SERVICE BULLETIN

Ride Name: Skycoaster®

Abstract of Issue: This bulletin addresses the inspection and maintenance of the triangulated Flight Bracket Catwalk and Support found on various lattice and crane mounted Skycoaster® attractions. Existing maintenance and inspection procedures must be followed, along with an additional inspection underneath certain components within the next seven days and on a monthly basis thereafter.

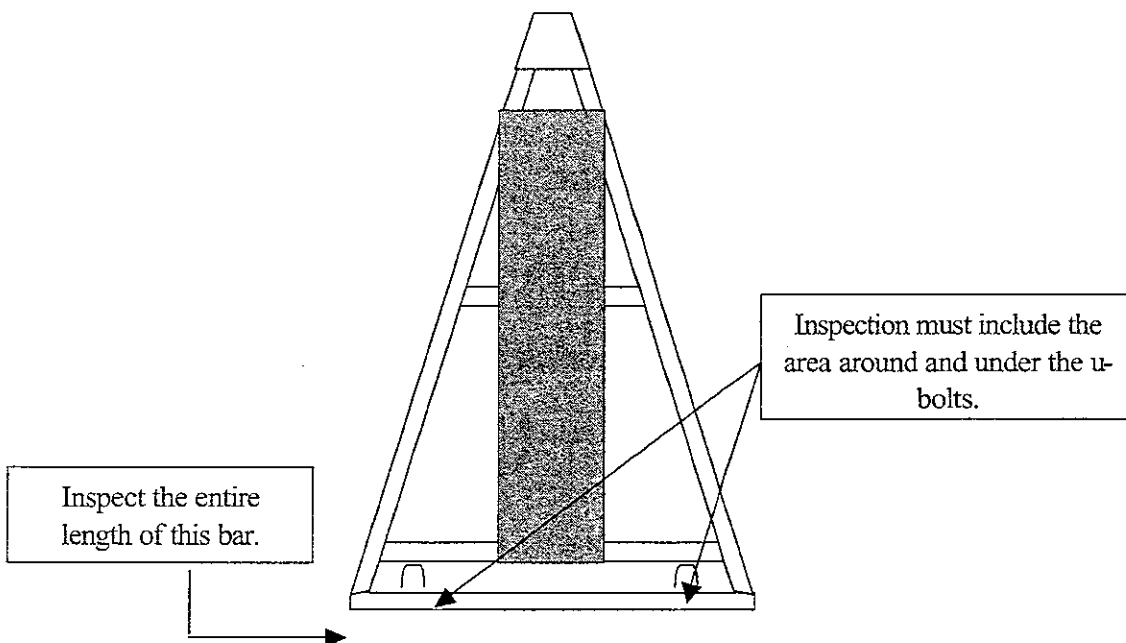
With the introduction of this Service Bulletin, we now require that all lattice and crane Skycoaster[®] sites utilizing the triangulated Flight Bracket Catwalk and Support perform an inspection of the Flight Bracket Catwalk and Support focusing on the support pipe which attaches the Catwalk to the flight tower. Inspect for cracks along the length of the pipe and/or cracks around the u-bolt mounting holes. The u-bolts will have to be loosened or completely removed to perform this inspection. Loosen each u-bolt individually, inspect and retighten before inspecting the next area. Follow all appropriate safety precautions while conducting the inspection.

Please refer to the drawing below for specific areas to be inspected.

If any deficiencies are found, immediately take the attraction out of service and contact Skycoaster, Inc. You are required to report the results of your first inspection of these components to Skycoaster, even where no deficiencies are found.

The inspection of these components must be included in each subsequent monthly and annual inspection.
